ADA Curb Ramp New Construction Inspection Form (Blended Transition)

NW MAIN ST

24953

NW NORTH AVE

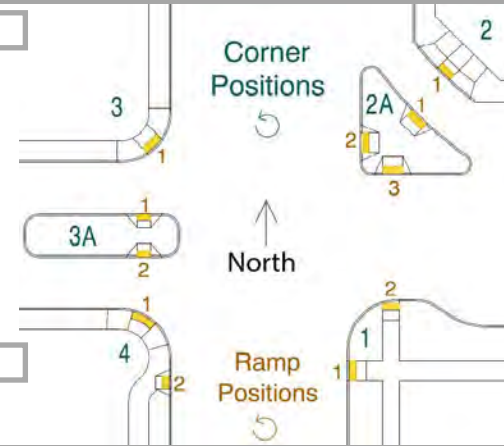
Comments:

Crack through curb and gutter
